**SANTEE COMMUNITY CENTER
CIP 2018-31**

ADDENDUM NO. 5

This Addendum No. 5 (32 pages in total) forms an essential part of the contract documents by revising the following:

A1 1ST FLOOR - ARCHITECTURAL SITE BUILDING PLAN
A1.21 1" = 30'-0"

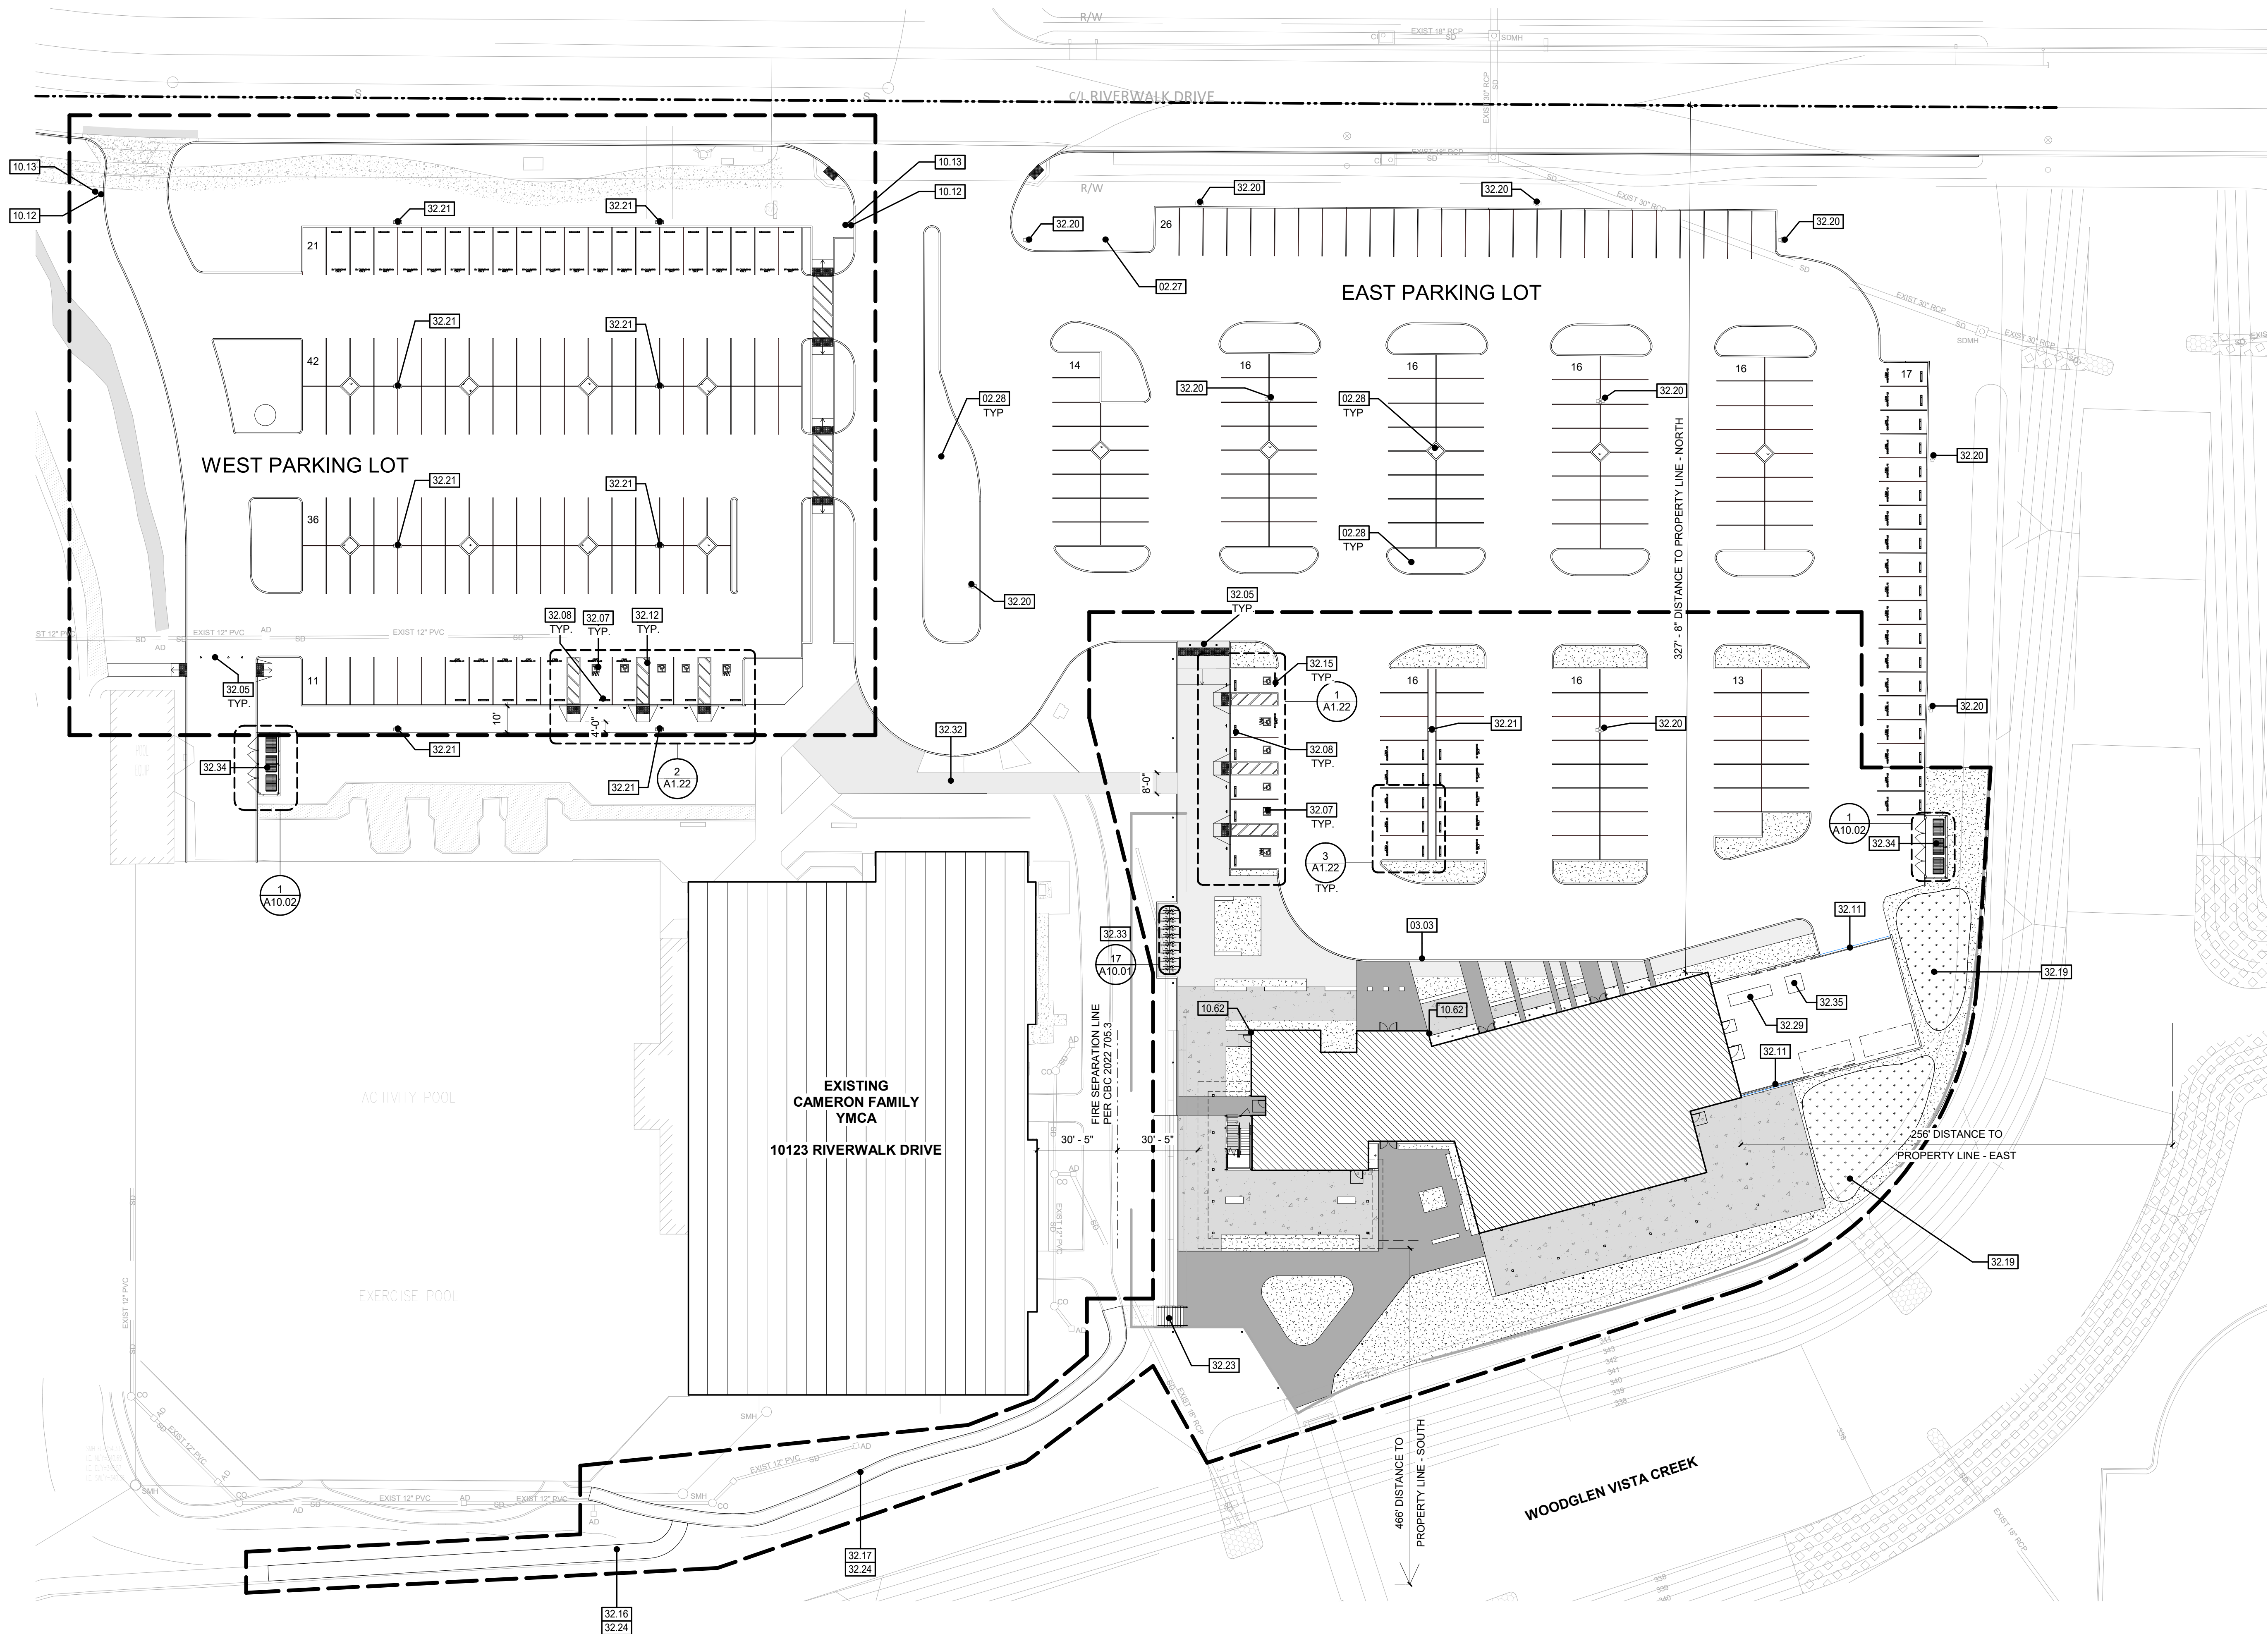
- 5C-1 Drawing Sheet **A1.21 - SITE PLAN**
- Revised legend to clarify finish and color of shaded concrete on plan.
- 5C-2 Drawing Sheet **A2.13B - 1ST FLOOR - SEGMENT B - FINISH PLAN**

5D-24 Question: Please clarify the specific color(s) and finish(es) required for the concrete paving, reconciling the three shades of gray shown on Sheet A1.21 with the "Medium Salt Finish" noted in Specification Section 32 13 13.

Response: Refer to revised sheet A1.21 issued as part of this addendum.

A1 1ST FLOOR - SEGMENT B - FINISH PLAN
A2.13B 3/16" = 1'-0"

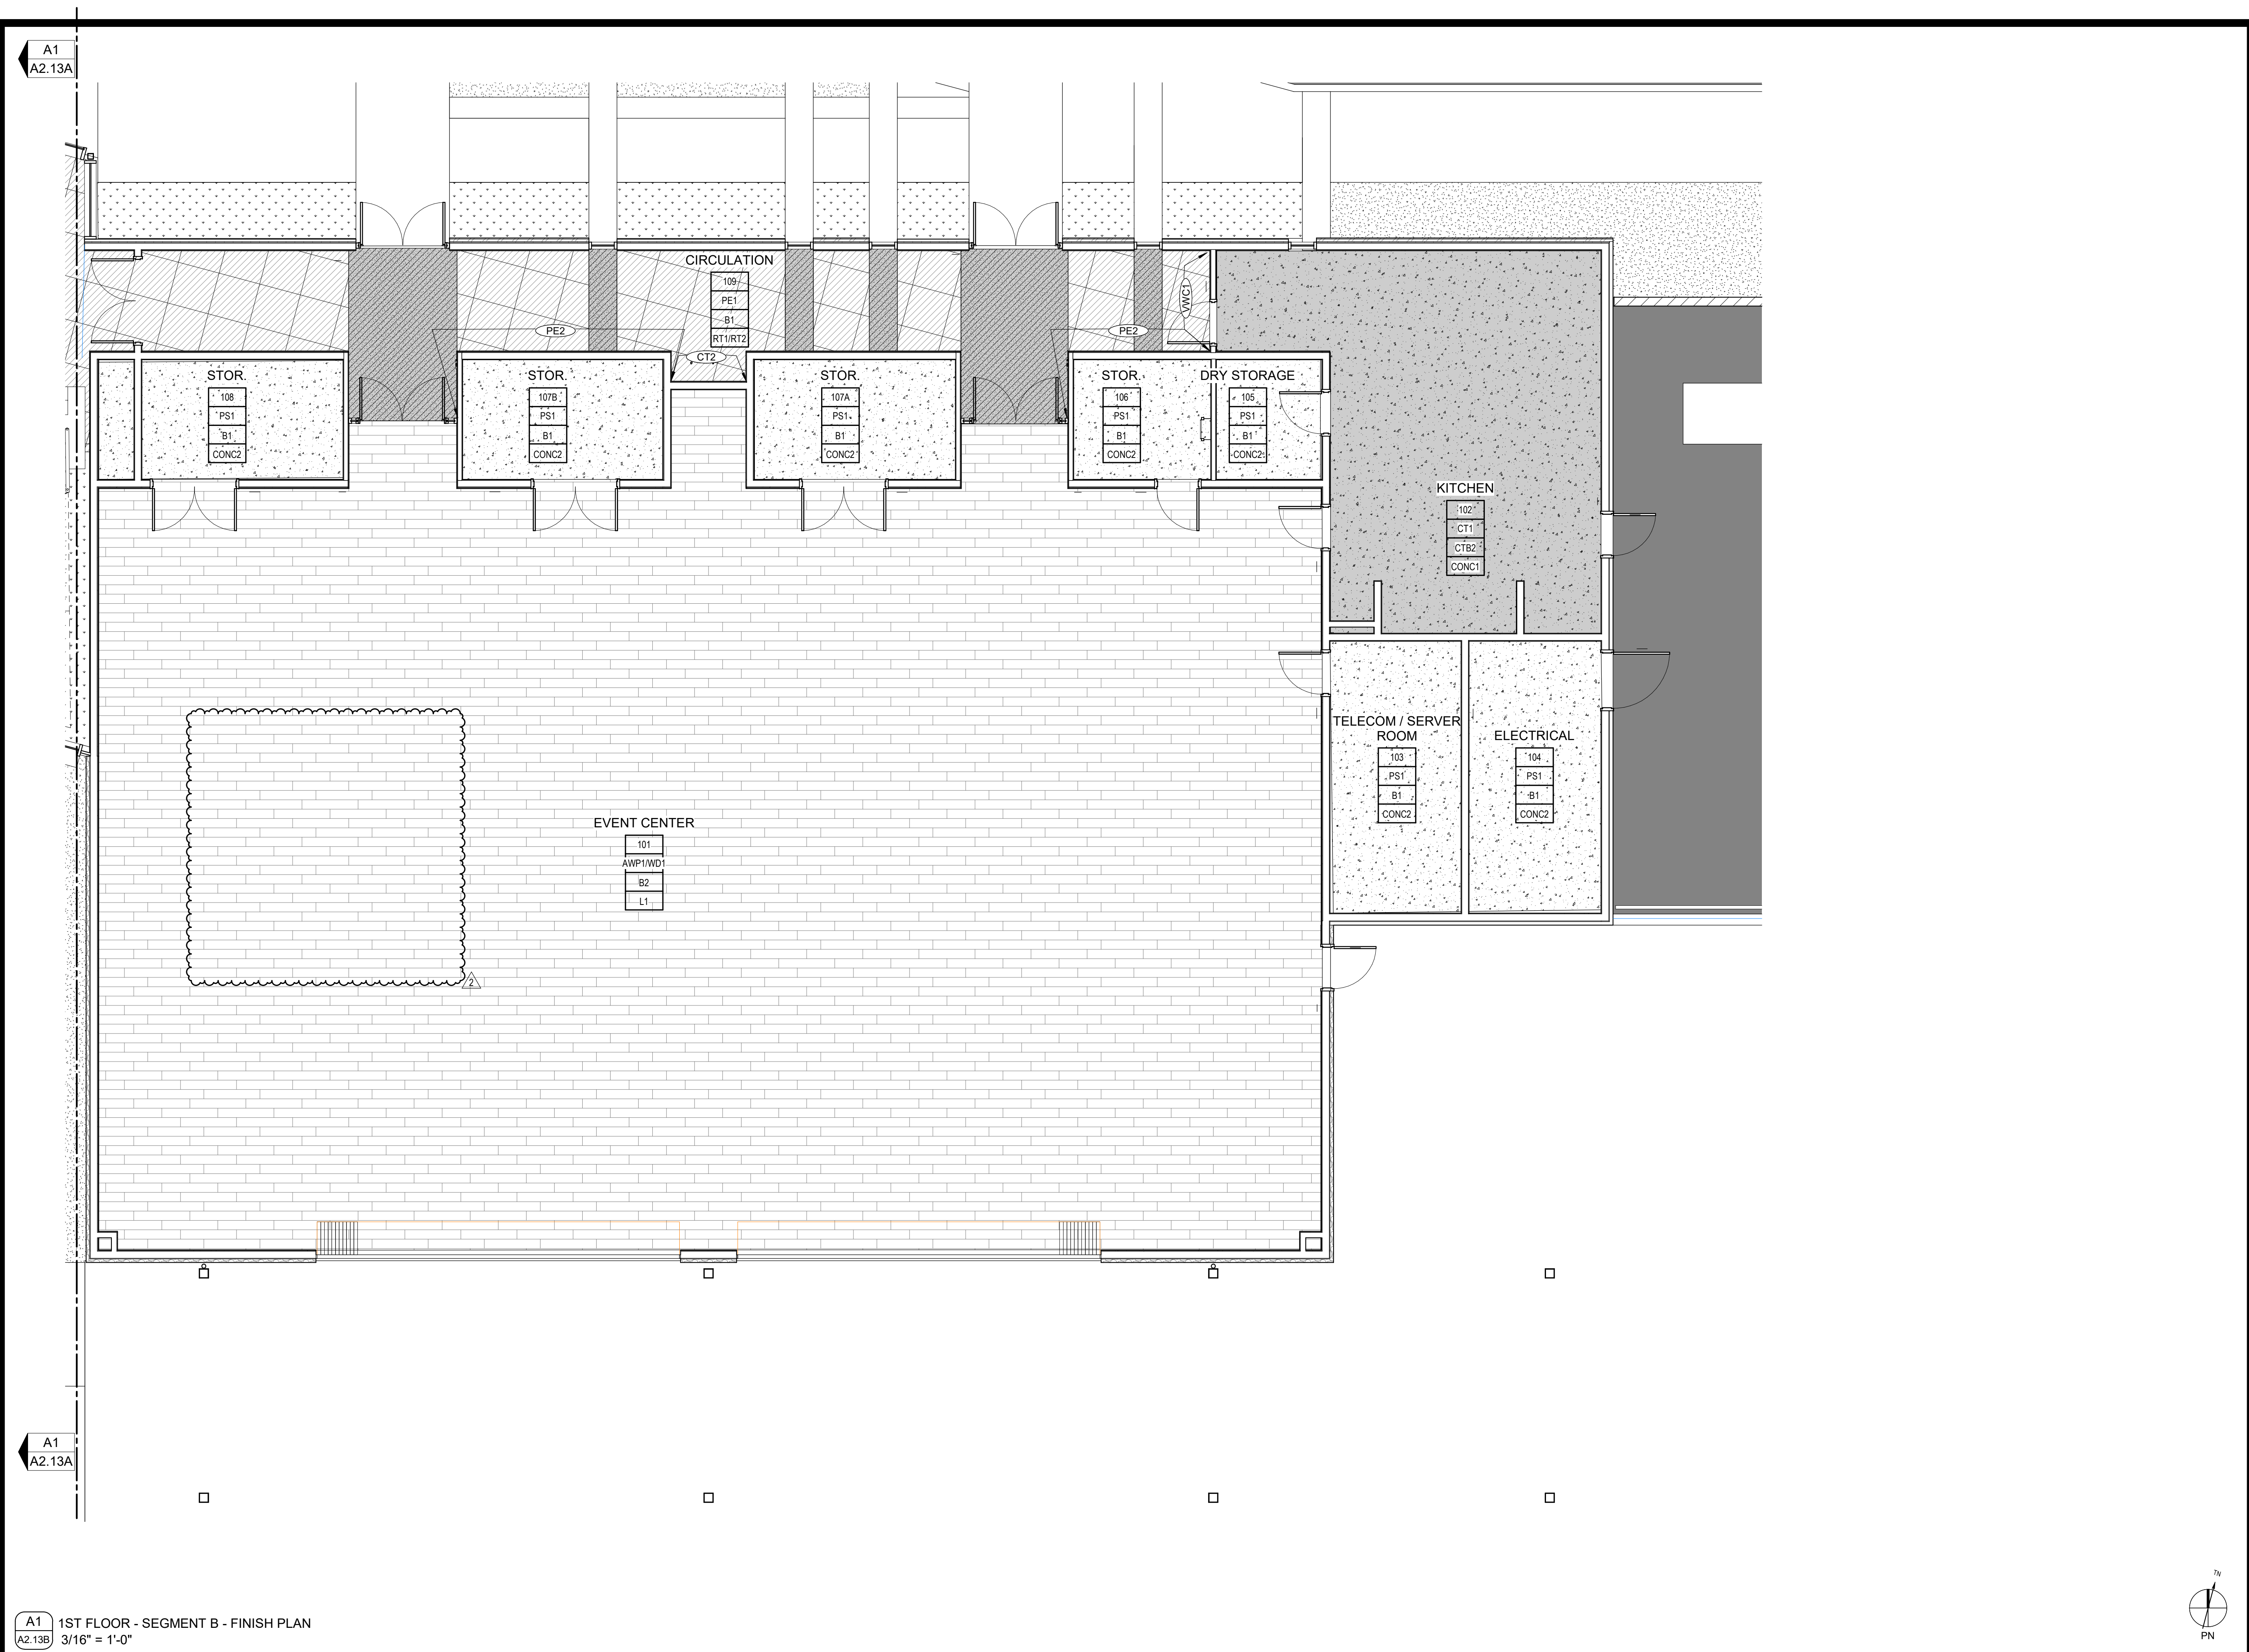
- For clarity, removed graphical error that was covering up flooring.
- 5C-3 Drawing Sheet **A3.11A - 1ST FLOOR - SEGMENT A - REFLECTED CEILING PLAN**
- For clarity, added callouts manual roller shades in offices.

A1 1ST FLOOR - SEGMENT A - RCP
A3.11A 3/16" = 1'-0"

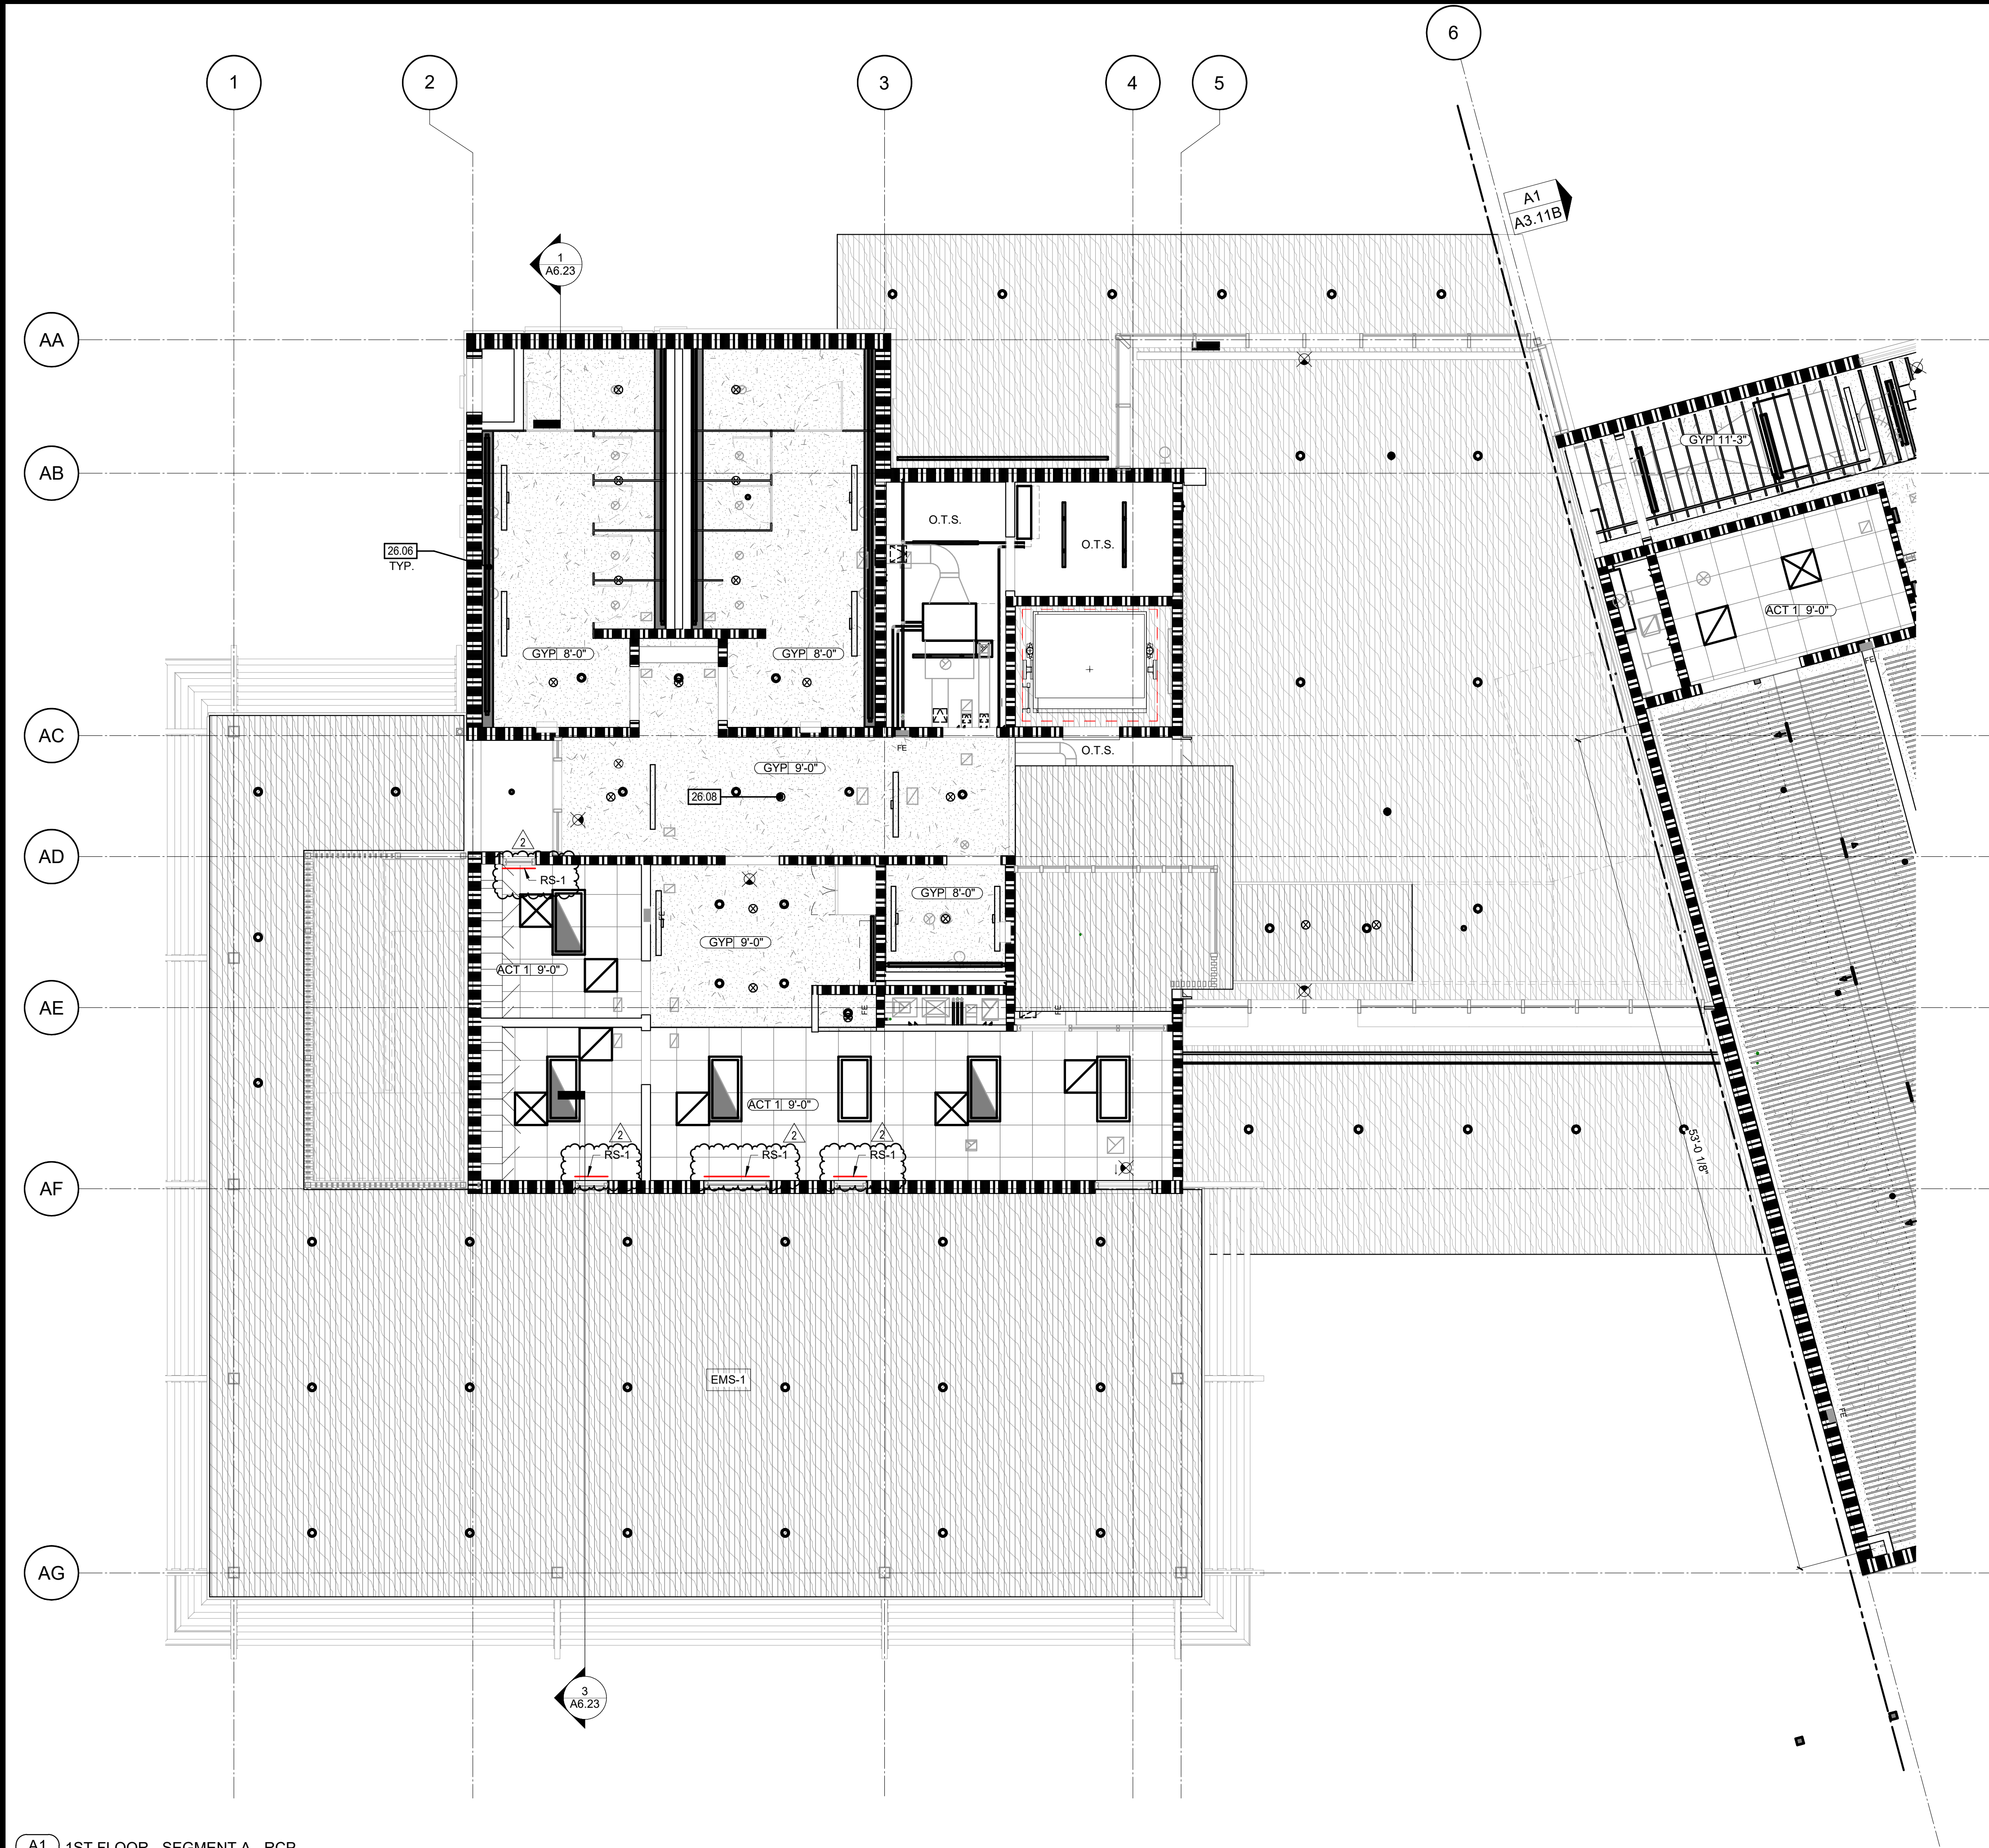
5D-16 Question: There is a spec for window coverings, roller shades (Spec 12 24 13). Page A9.22 shows RS-1 is for Shades. However there are no markings on the floor plans, or RCP plans etc. for RS-1 Shades.

Response: Refer to revised RCP sheets issued as part of this addendum.
